ADDENDUM

PROJECT: Jefferson Community Health Center
Patient Wing and Administration Renovation
Fairbury, Nebraska

AD-2

DATE ISSUED: Friday, January 25, 2013

3 Screen Wall Section
 Scale: 1" = 1'-0"

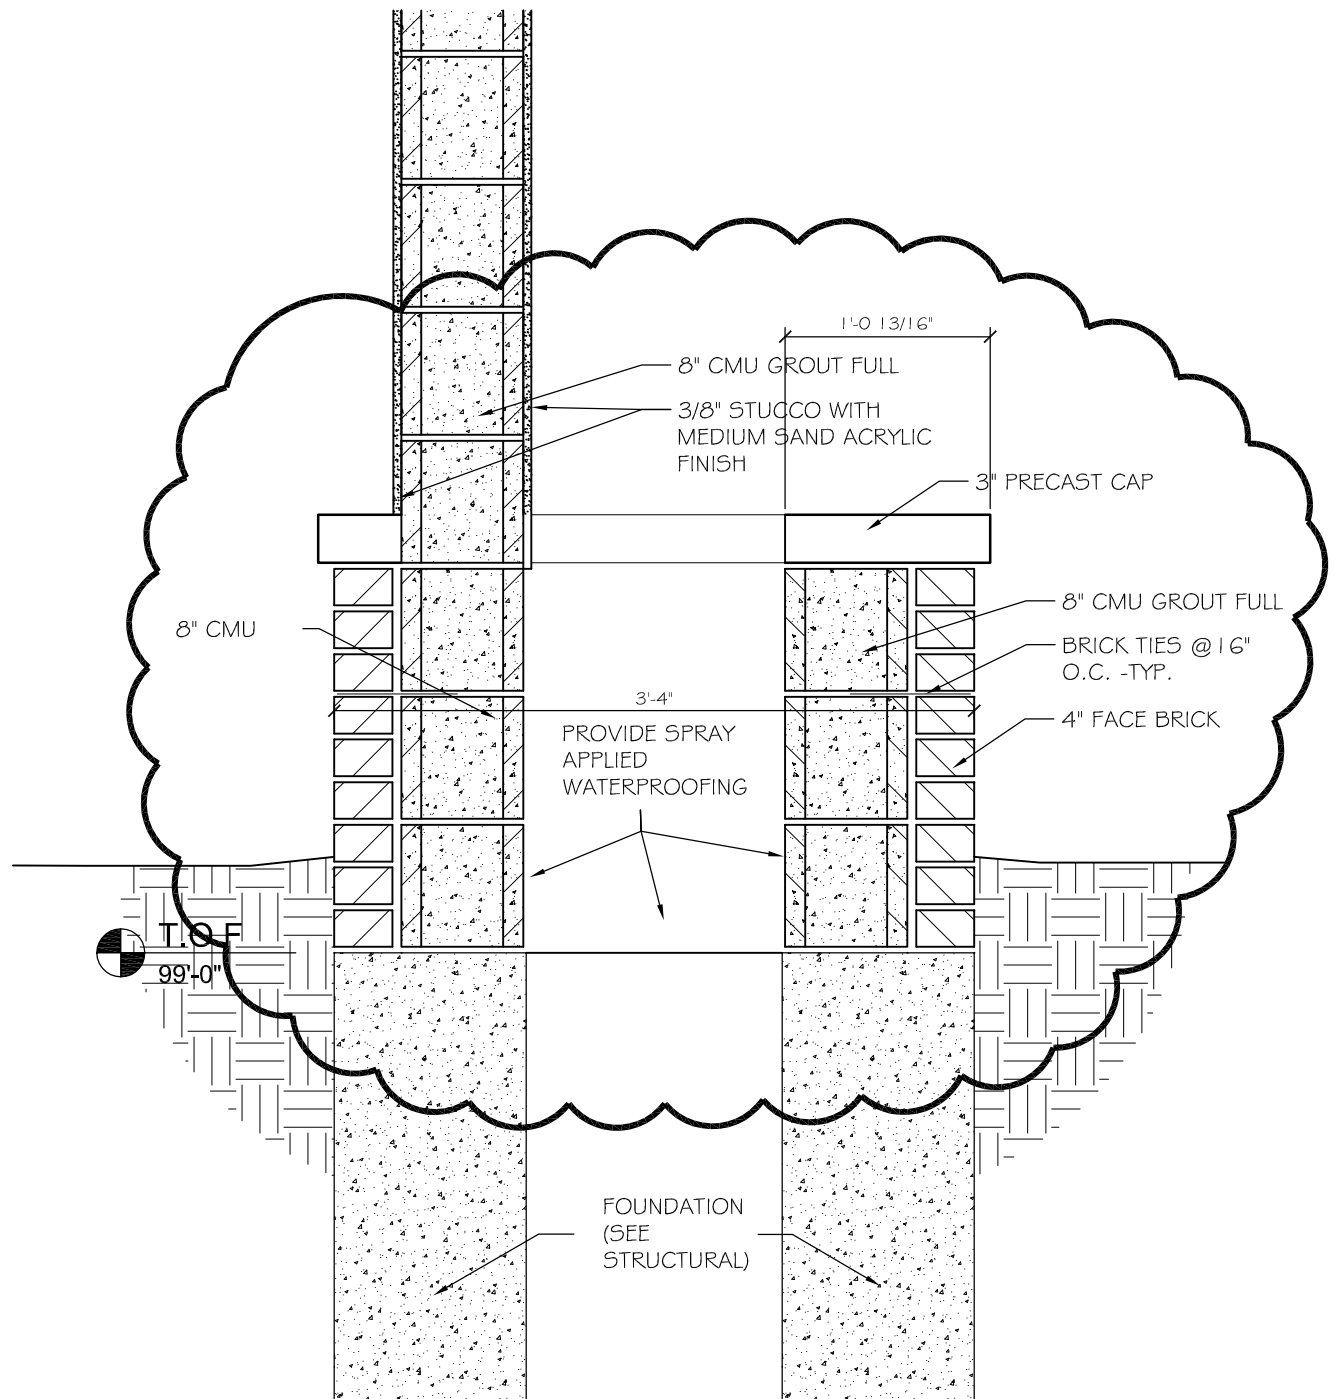
In reference to **Sheet C-104 Detail 3, Screen wall Section**, please refer to the attached revised detail C104.1

Courtyard Lanscaping Plan

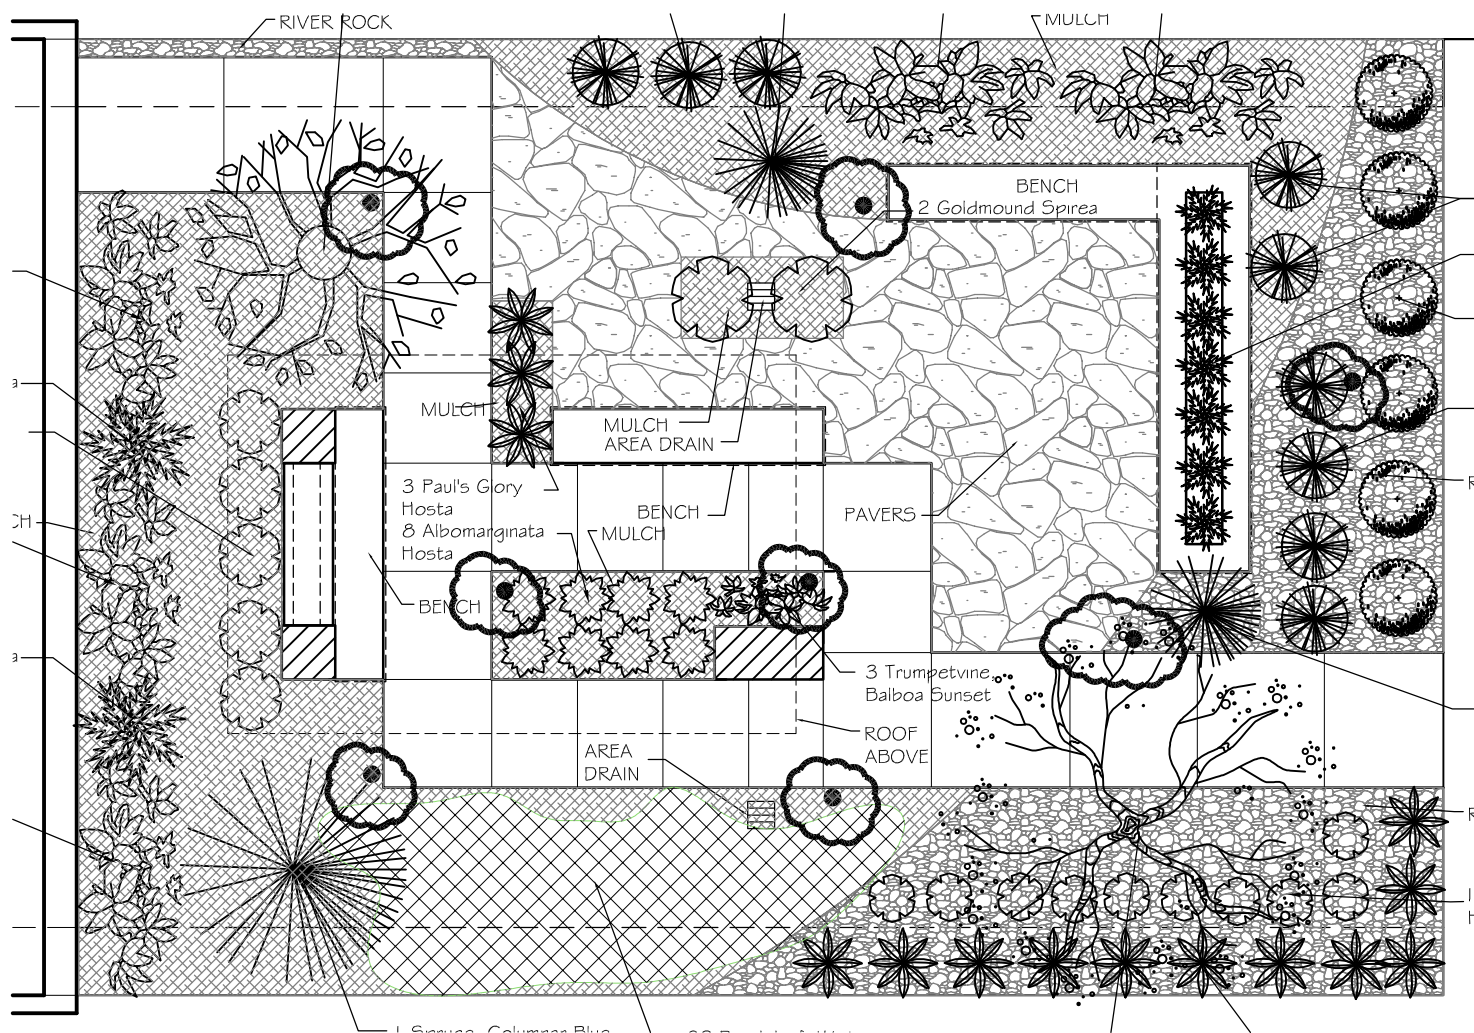
In reference to **Sheet C-105**, Landscaping Plan, see attached Sheets C-105.1, C-105.2, and C-105.3 for revised Landscape plan changes.

1 Demolition Plan - Area C
Scale: 1/8" = 1'-0"

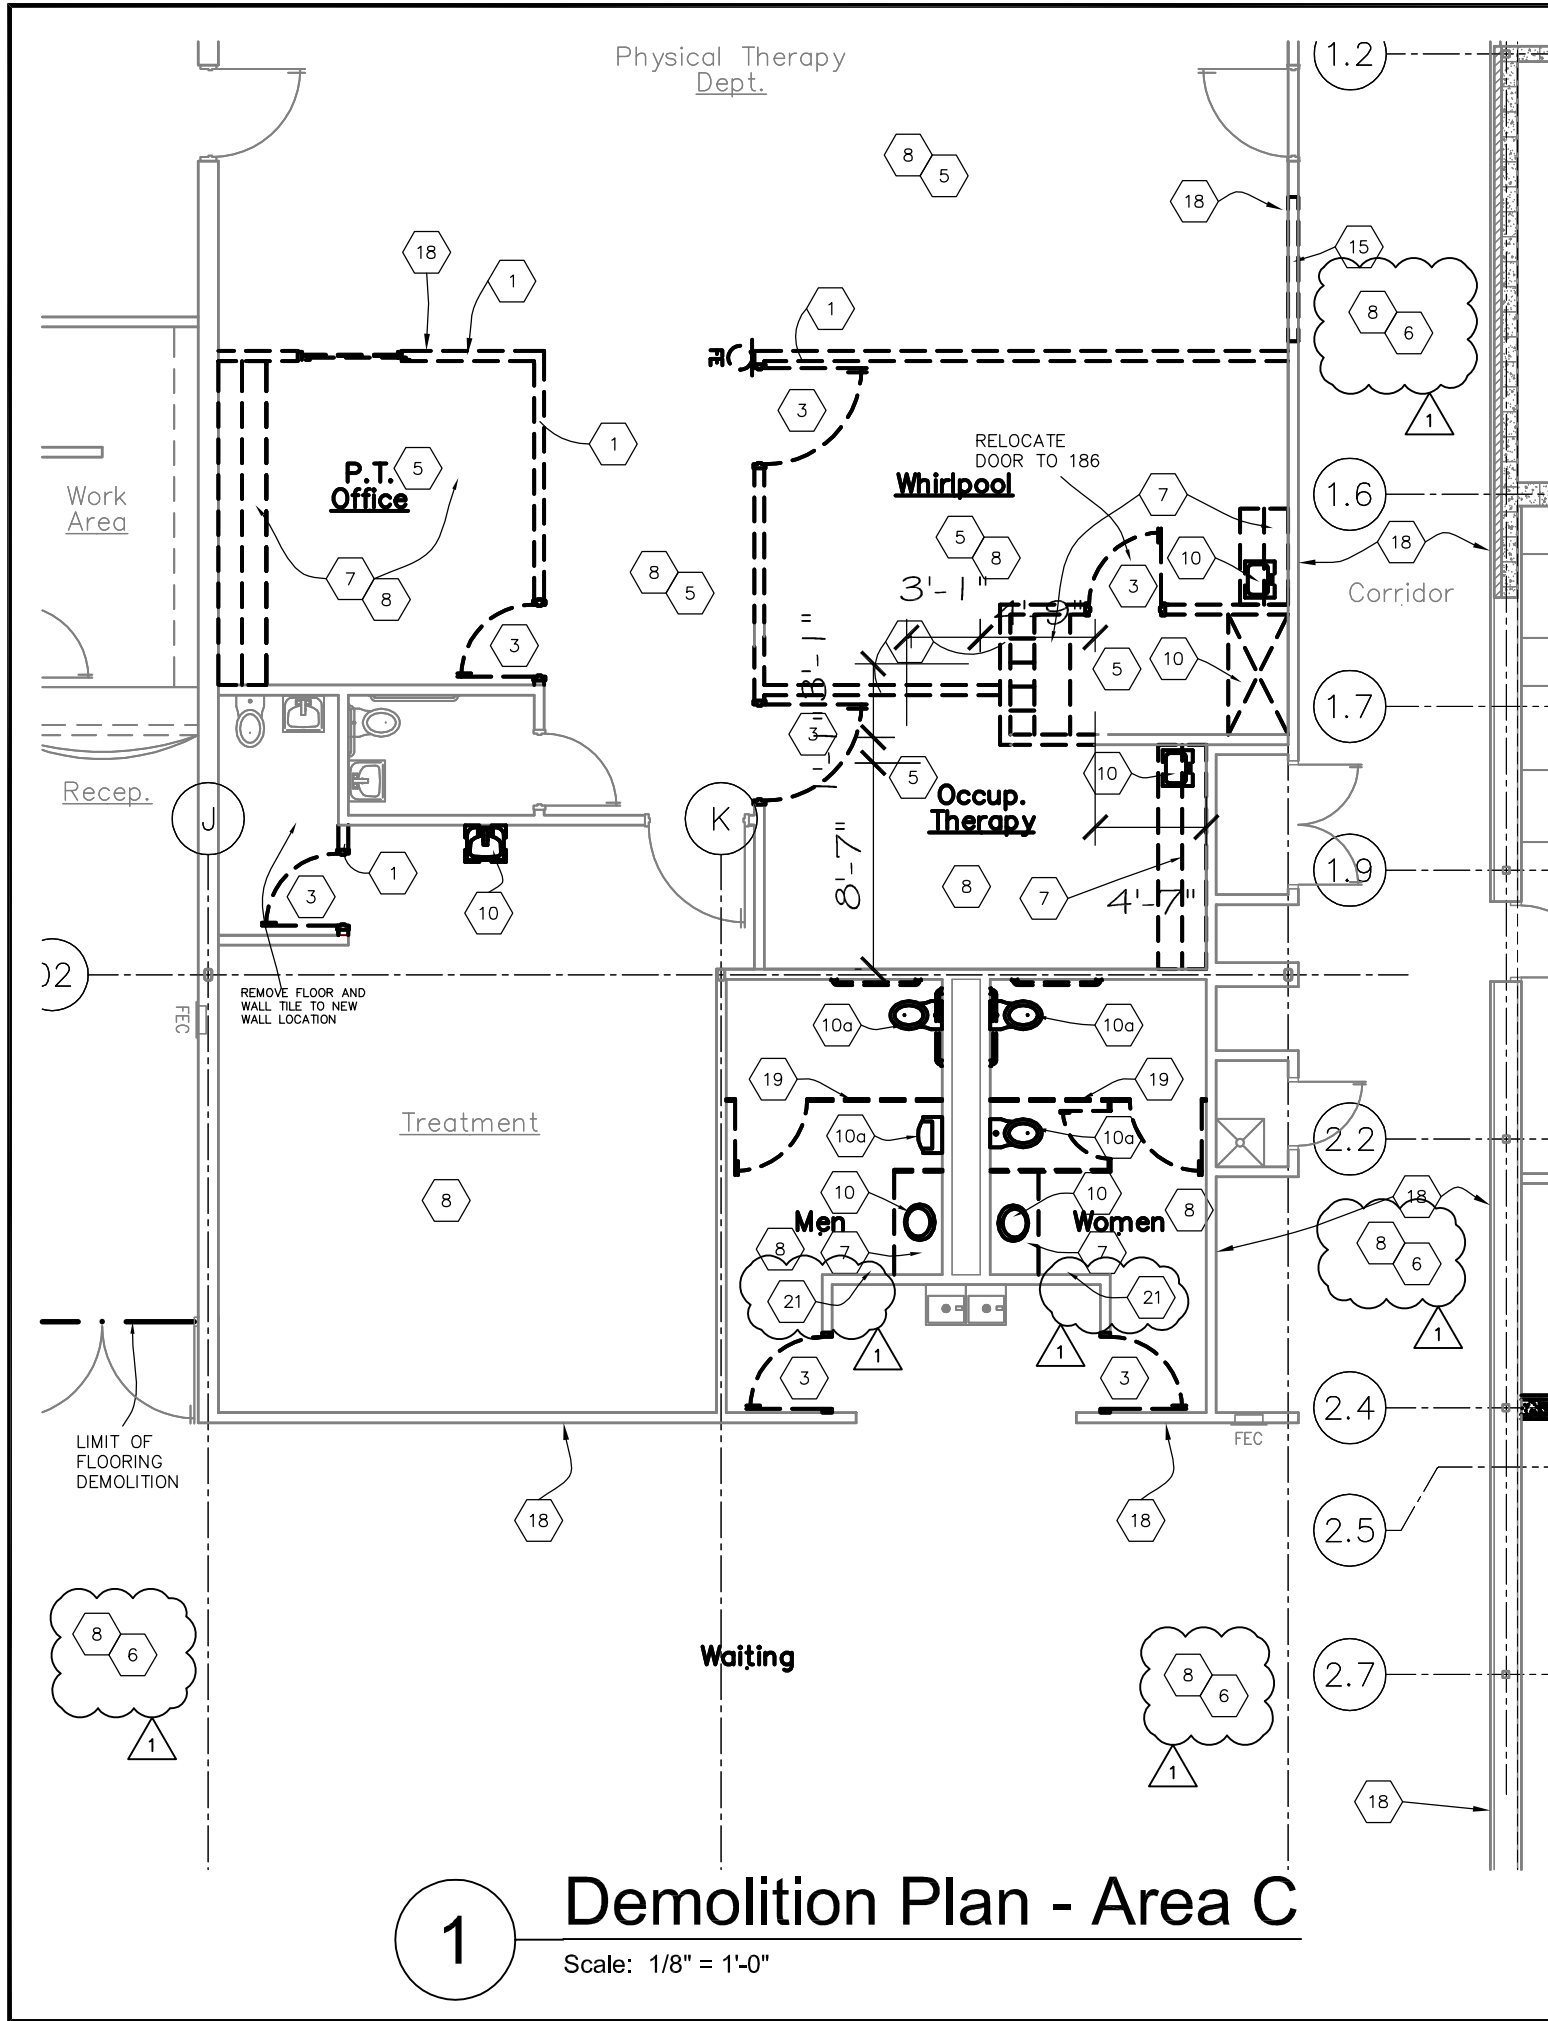
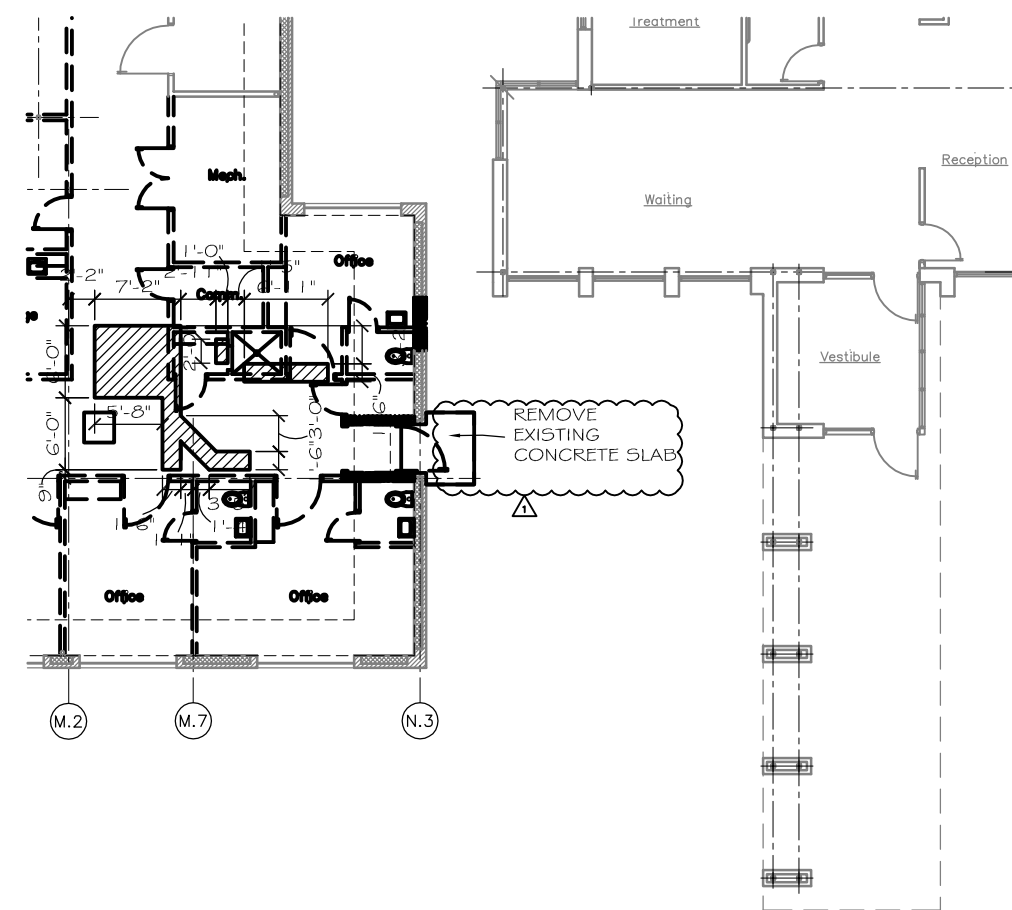
In reference to **Sheet AD-102**, see attached Sheet AD-102.1 for revised demolition and concrete demolition plan.

1 Demolition Plan - Area A

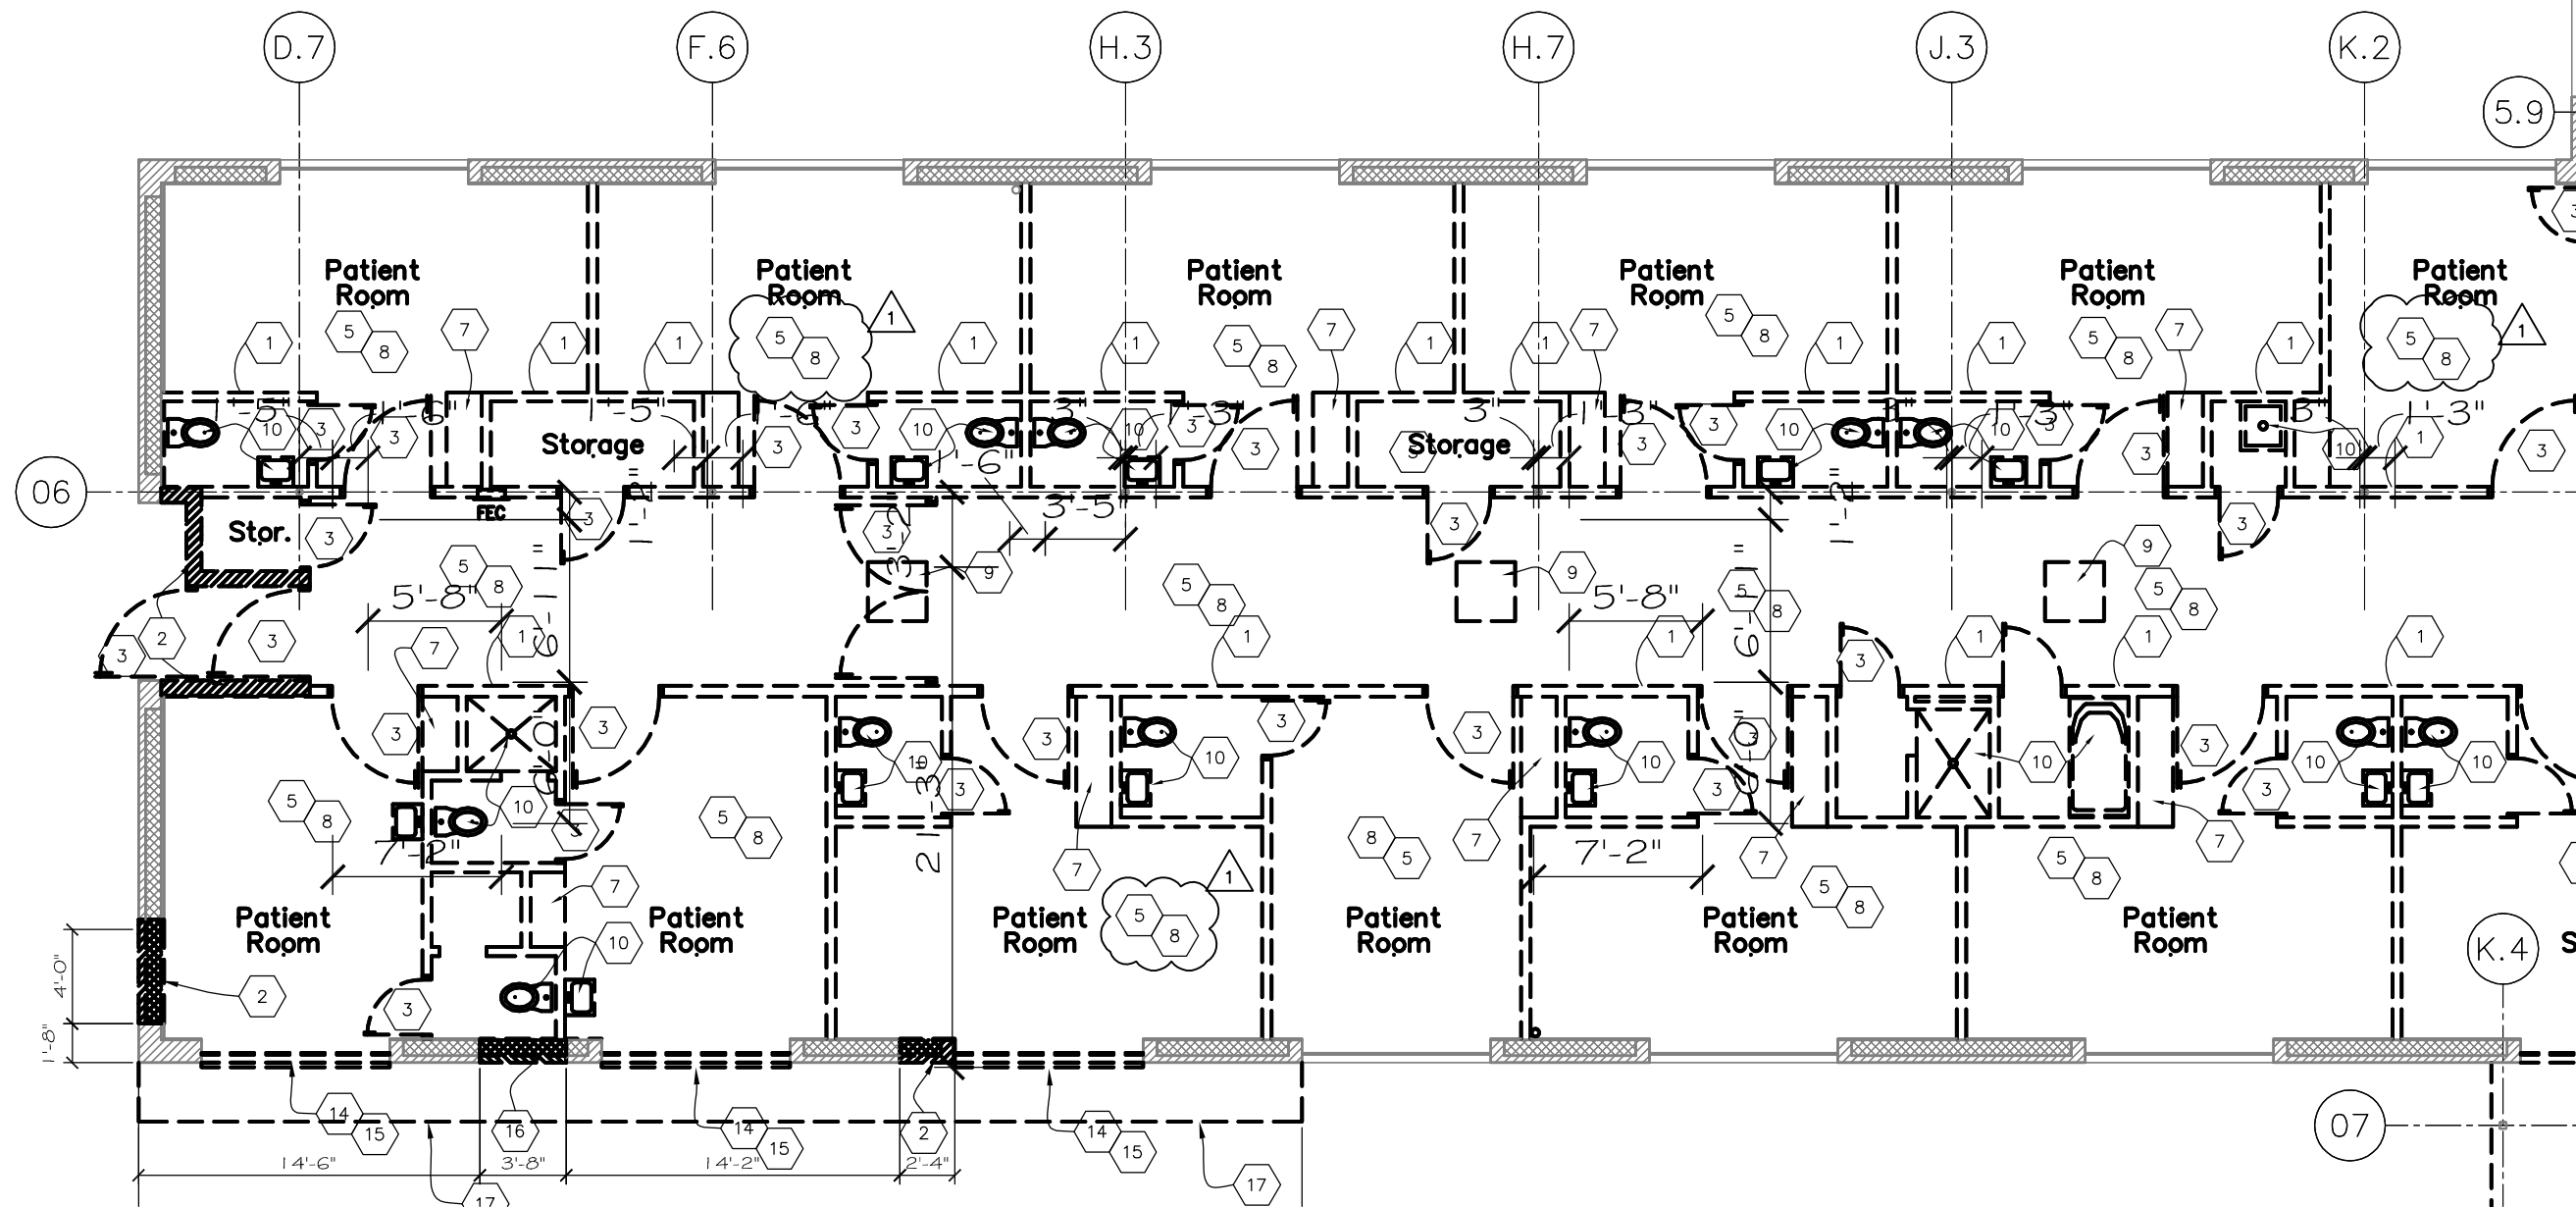
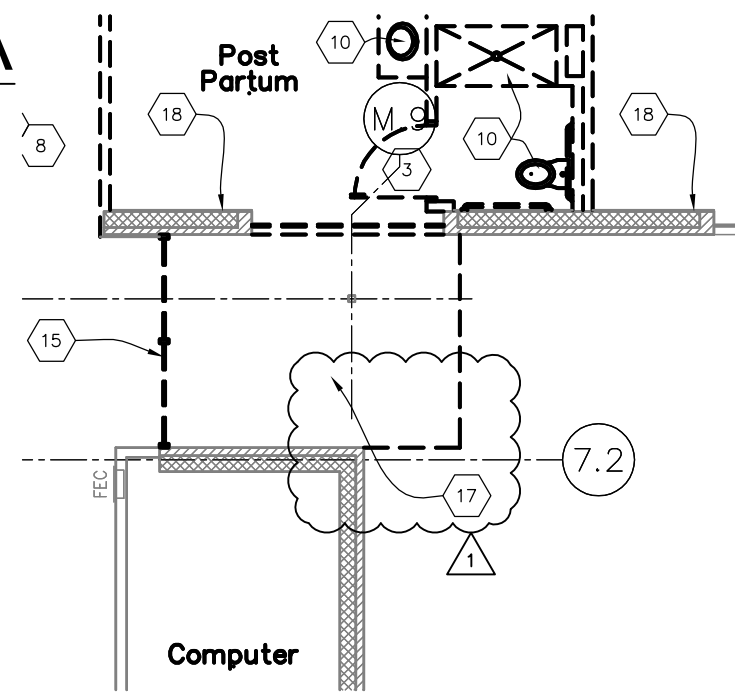
In reference to **Sheet AD-101**, see attached Sheet AD-101.1 for revised demolition plan.
